Housing Department - Report

Proposed Development: Construction of 49 no. residential units comprising; (i) 6 no. 1-bed apartment, (ii) 6 no. 3-bed duplex units, (iii) 4 no. 3-bed 2-storey houses, (iv) 28 no. 2-bed 2-storey houses, and (v) 5 no. 2-bed single-storey houses., along with all necessary ancillary site development works, at Ballygunner Castle Road / St. Mary's Place, Ballygunner,, Waterford City.

Observation - Summary Spreadsheet

Section AA with superimposed existing neighbouring house relative to proposal (excavated ground means that the new developments ground line sits lower).

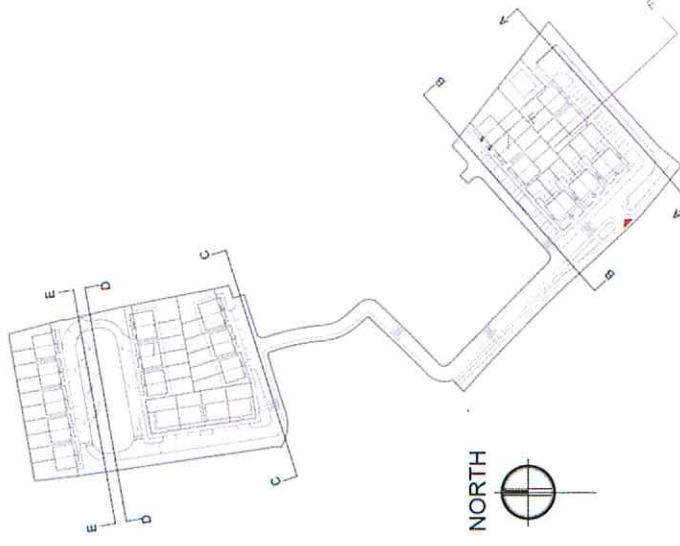
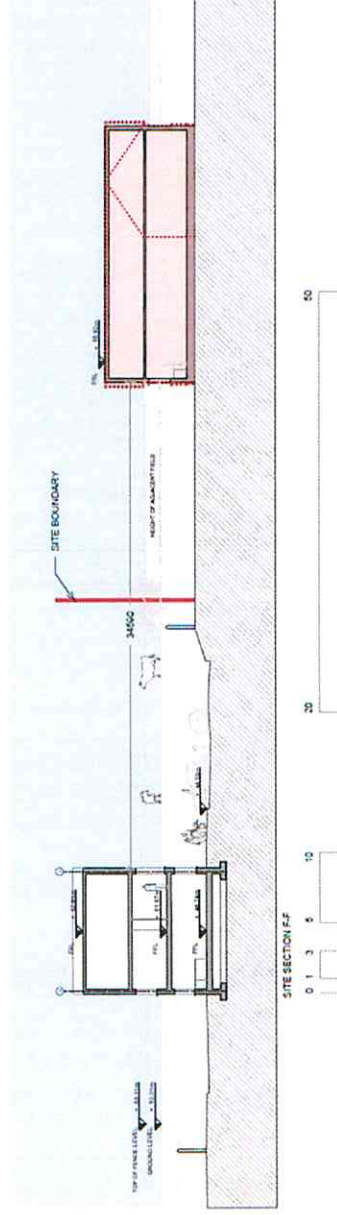
<p><i>There are no windows on the end-gable to the proposed 2-storey houses referred to, so there will be no overlooking and no violation of privacy to the existing row of bungalows, as suggested.</i></p>	<p>No change to Part 8 drawings.</p>
